Subject: Jaguar Recall J028 – Engine Cut-out - Dealer Communication

TECHNICAL BULLETIN

J028NAS2
10-JAN-13

Safety Recall: Fuel Starvation

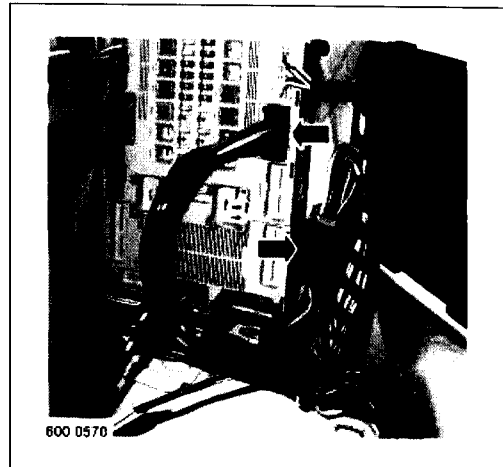
4. Disconnect the connector.

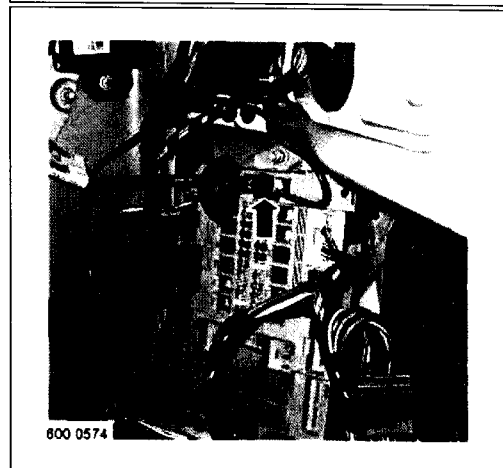
5. Install the new link lead and relay harness.
 - Connect the two (2) connectors.

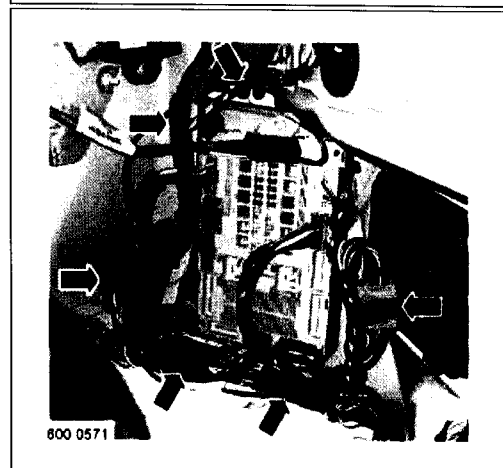
6. Secure the M8 eyelet to the battery cable connection.
 - Feed the new harness along the existing harnesses in the position shown.
 - Re-position the battery cable connection cover.
 - Remove the nut.
 - Install the M8 eyelet on the stud.
 - Tighten the nut to 12 Nm.
 - Re-position the battery cable connection cover over the connection.

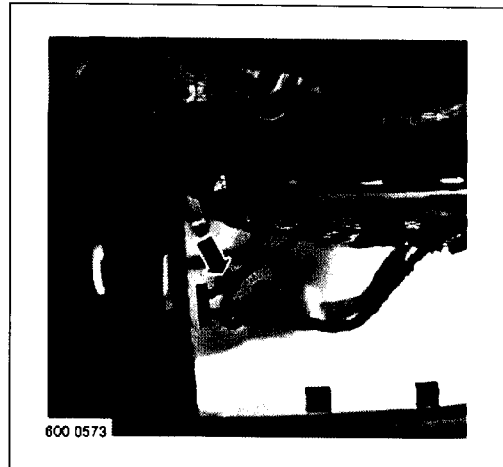
7. Using a suitable tape, secure the new link lead and relay harness to the existing harnesses in the positions shown.

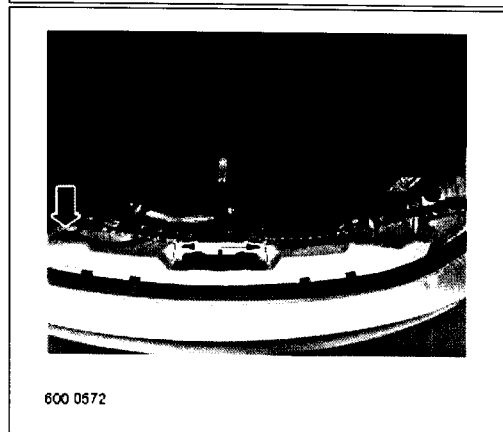
9. **⚠ CAUTION: Make sure that the ground cable is fully secured in the area of the luggage compartment lid latch, so that the ground cable cannot come in to contact with the latch. Failure to follow this instruction may result in damage to the vehicle.**

Using suitable tape, secure the ground cable to the underside of the existing harness at suitable points along the rear panel of the luggage compartment.

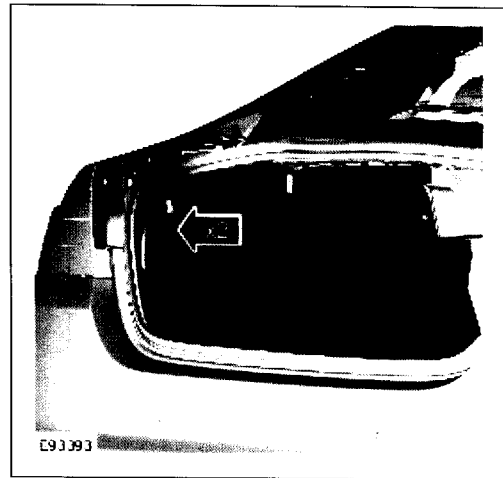
11.  **NOTE: Left-hand shown; right-hand similar.**

Secure the RH loadspace trim panel.
